Skamania County Hearing Examiner

Swift Forest Camp Improvements

- **File no.:** SHR-20-02/CA-20-02
- **Permit(s) requested:** Shoreline Substantial Development Permit, Shoreline Variance, and Critical Areas Variance
- **Project description:** The applicant (PacifiCorp) a Shoreline Substantial Development Permit, Shoreline Variance, and Critical Areas Variance in order to construct several improvements to the Swift Forest Camp related to the Americans with Disabilities Act (ADA). The applicant will install new pathways, a new dock access ramp, a new ADA play structure, and several ADA picnic tables.

ADA IMPROVEMENTS AT SWIFT FOREST CAMP DOCK AREA PLAN

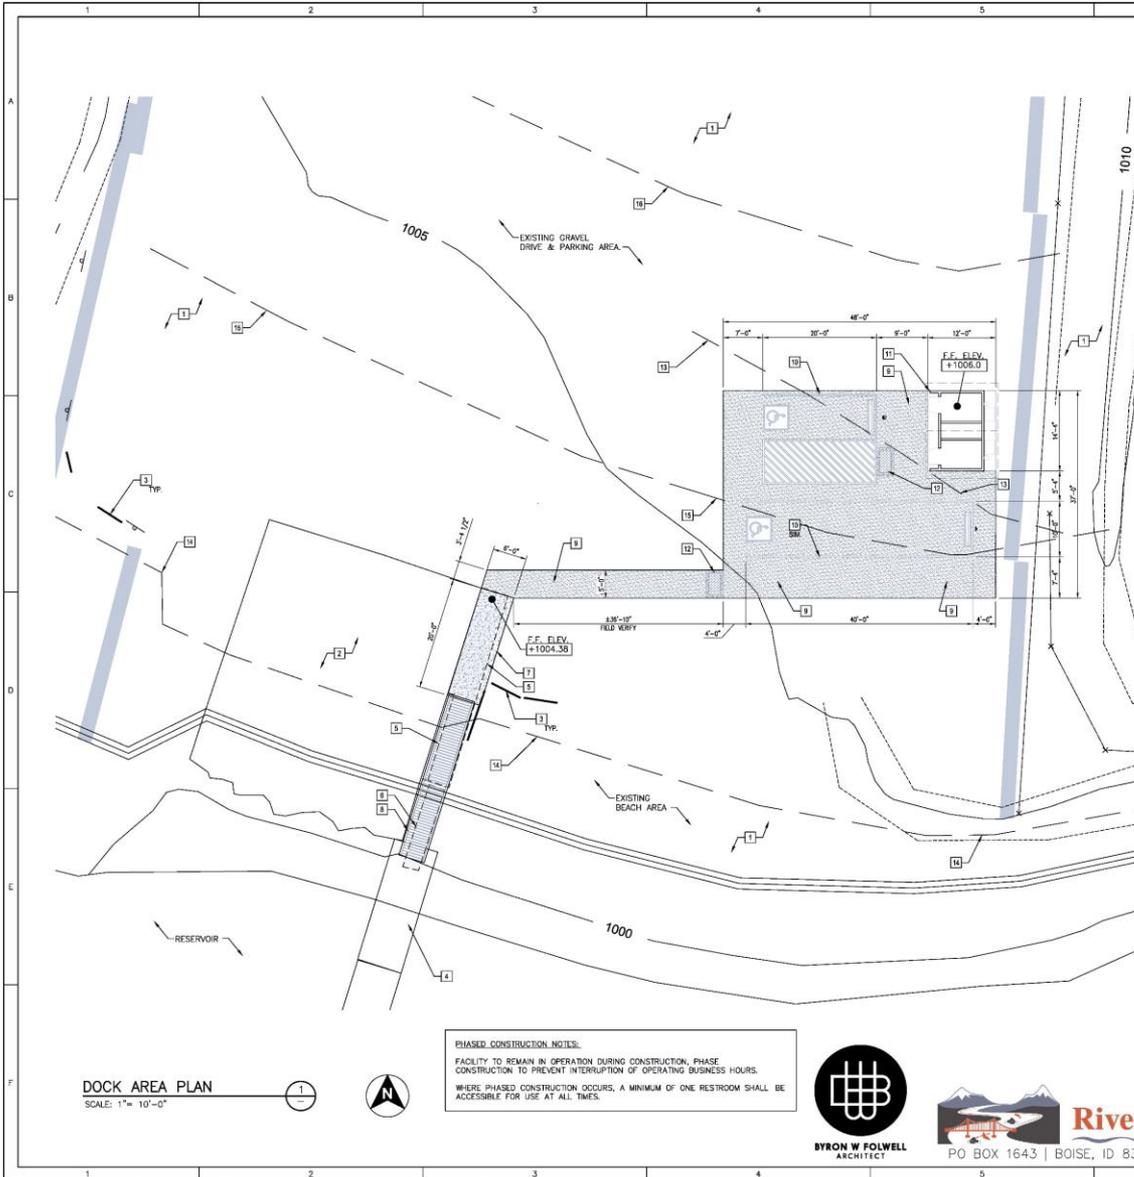
- **The Conservancy environment requires a 50 ft. setback for all buildings and structures.**
- A portion of a new ADA parking area, hard surface path, and improvements to the existing dock and gangway are within the 50 ft. setback area.
- The proposal has been reviewed for compliance with shoreline variance criteria in SCC 20.20.040 and the variance criteria in the Shoreline Master Program.

- **The Swift Reservoir has a 150 ft. buffer requirement.**
- Variances required for new ADA parking area, vault toilet, hard surface path, improvements to the existing dock and gangway, and new play structure.
- The proposal has been reviewed for compliance with variance criteria in SCC 21A.04.030 and 21.16.070.

Staff recommends that the request for a Shoreline Substantial Development Permit, Shoreline Variance, and Critical Areas Variance be approved with the conditions listed in the Staff Report.
